# Appendix J    Comments on the Draft EIS

Subject: Comments – Draft Environmental Impact Statement, Resource Management Plan Amendments and Plan of Development for the SunZia Southwest Transmission Project, Dated May 2012

To: State Director, New Mexico Bureau of Land Management  
From: Regional Director, Intermountain Region *[Signature]*  
Subject: Draft Environmental Impact Statement and Resource Management Plan  
Amendments for the SunZia Southwest Transmission Project. Transmittal of  
National Park Service Comments.

Figure 1 NPS Proposed Optional alignment for transmission line near Gran Quivira. The entire option as presented is within BLM's Study Area for the EIS.

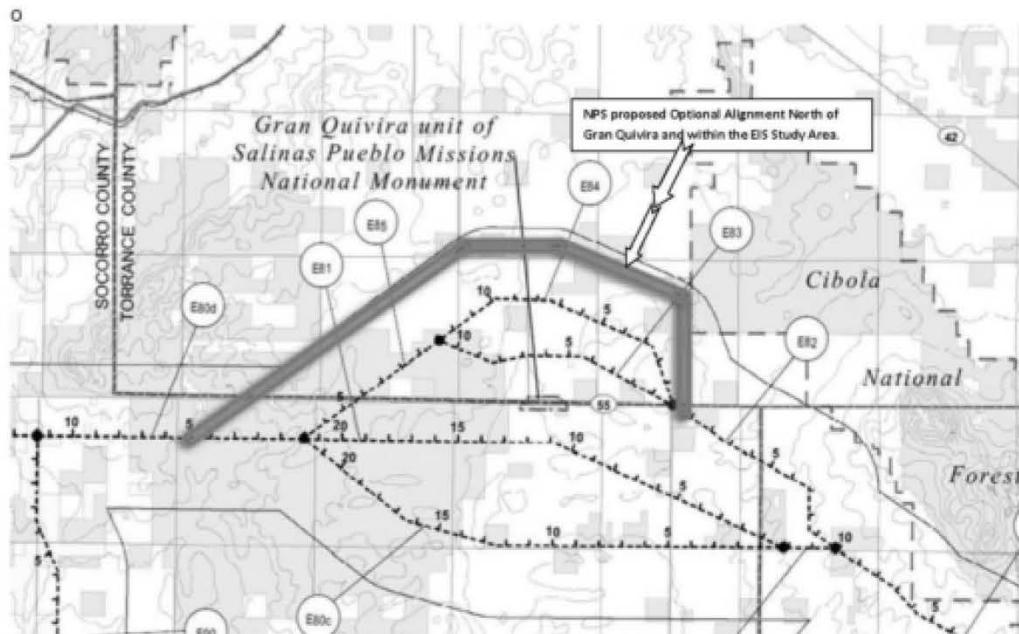
**1** The Park Service proposes that an optional transmission line alignment north of BLM's preferred alternative and north of Gran Quivira along the northern edge of and within BLM's study area (Figure 1 in NPS detailed comments) be evaluated in the EIS. Salinas Pueblo Missions National Monument has conducted site tours of the entire area, observed residential landowners presence, and conducted consultation with some affected tribes to confirm that the optional alignment is appropriate for greatly minimizing potential impacts to NPS resources and for meeting BLM's project objectives.

Subroute 1A1 was identified in the Draft EIS as the BLM Preferred Alternative. The identification of Subroute 1A2 (the BLM Preferred Alternative) in this Final EIS was made in response to comments on the Draft EIS that requested modifications to Subroute 1A1 (segments E84, E80 and E101) in order to increase the distance between the transmission lines and the Gran Quivira as well as the distance between the transmission lines and military missile launch complex 94 (LC 94).

Figure 1

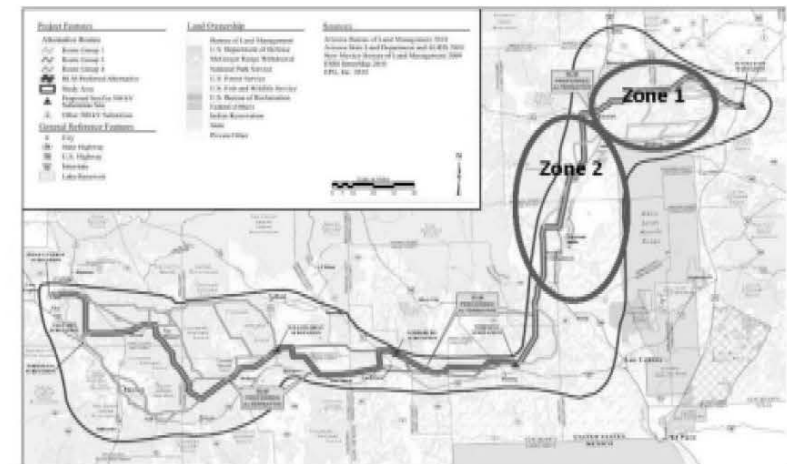
**Background:** As a common frame of reference, the BLM provided draft EIS maps have been used in this point paper. This point paper will focus on an updated analysis on zone 1 lines and will not address zone 2 lines. Zones 2 impacts have not significantly changed from the previous analysis which determined these routes to have a "less than significant impact" to WSMR operations (ref WSMR memo to ATEC dated 6 Dec 2010)

Figure 2

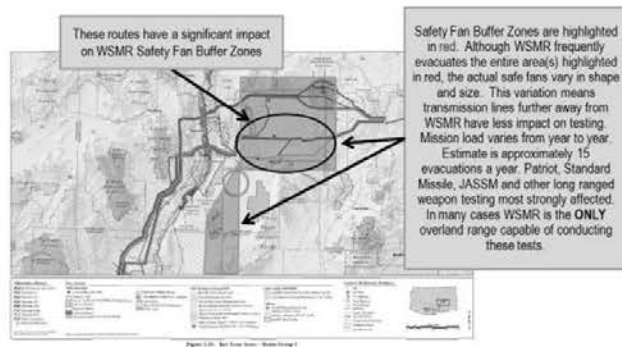
**Safety Fan Buffer Zones.** Some of the alternative BLM routes include segments which will be inside safety fan buffer zones developed for a variety of surface to air and air to ground systems (see figure 2). The BLM preferred route removes approximately 245 sq miles of usable safety fan buffer zone area which is ~4.1% of WSMR total usable safety fan area. The impact of this removed area is considered "less than significant" to WSMR operations as safety fan buffer zones typically don't reach the top of the extension area. However, routes inside the black circle shown in figure 2 are considered to have a significant impact. Please note that as weapon ranges increase, or altitudes increase or the system possess a larger warhead, or has more aerodynamic lift, the safety fan buffer zones become larger.

Figure 3

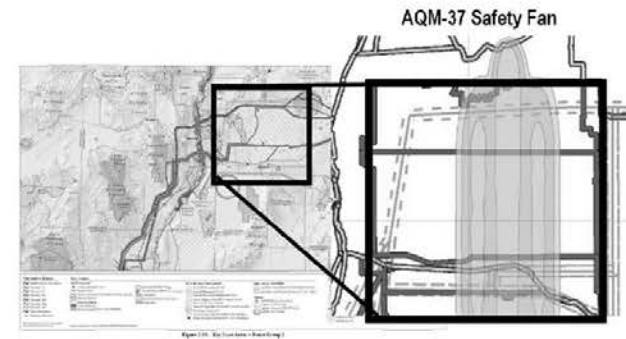
WSMR has recently experienced an increase in long ranged testing. Figure 3 shows the safety fan buffer zone associated with an AQM-37 mach 3 target. The safety fan runs over all proposed SunZia routes. If the integrated probability to damage the lines was above  $10^{-5}$ , this test would not be possible or some

mitigation approach would be required. Possible mitigation strategies are: 1) de-energized the power lines during the test activity, or 2) change of DoD risk management policy regarding national infrastructure.

Figure 5

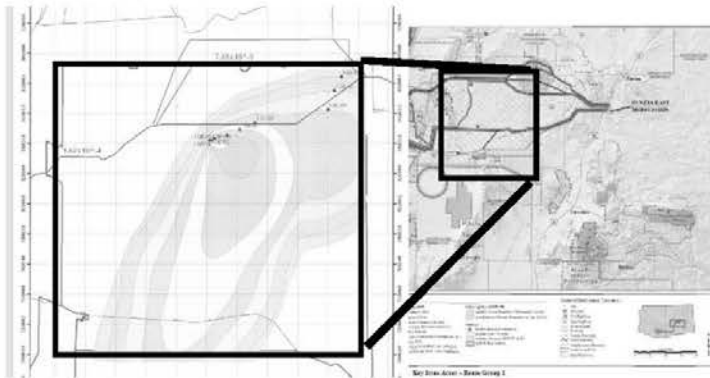
Figure 5 shows probability curves associated with a target launch out of LC94. The rainbow colored lines show the probability contours from a failure. The straight segment blue line on the left hand side of the figure is the BLM preferred route. Note the integrated probability of impacting the line from an "average" target launched out of LC94 is  $1.07 \times 10^{-4}$ . This is above the DoD standard of  $10^{-5}$ . Also shown on the figure is a possible transmission line route around the launch complex (red and green lines) with the associated probability of impact at  $7.85 \times 10^{-6}$  well below the DoD standard.

As suggested in figure 5, a possible mitigation for the debris impact problem is for the SunZia transmission lines to be route around the LC94 launch complex. Figure 6 shows a possible route (the green WSMR 2b route) which will reduce the probability of impact to  $\sim 10^{-5}$ , this is well below the DoD standard. This route is  $\sim 2$  miles longer, than the preferred route.

Figure 7

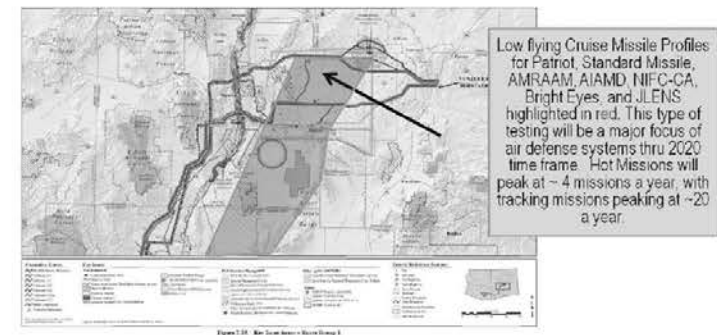
**Cruise Missiles Targets.** Cruise missile targets are negatively affected by the physical presence of power lines as shown in figure 7. In some cases, cruise missiles targets are flown at altitudes equivalent to the height of the towers and connecting lines. The impact of the power lines precludes execution of these missions at WSMR. Cruise Missile targets (BQM-74s and MQM-107s) are routinely flown for Air and Missile Defense (AMD) systems such as Patriot, Standard Missile, JLENS, AIAMD, etc. For AMD radar testing, the cruise missile targets must fly at low altitude just like the threat system altitudes. The AMD radars must detect these low flying targets at extended ranges and in a clutter environment (i.e. the targets are flying at a very low level). It is critical to know the radar's performance envelope, particularly the maximum detection range of targets at low altitude in a clutter environment. If the target has to "pop up" over infrastructure – this invalidates the test, as the radar will easily detect the target.
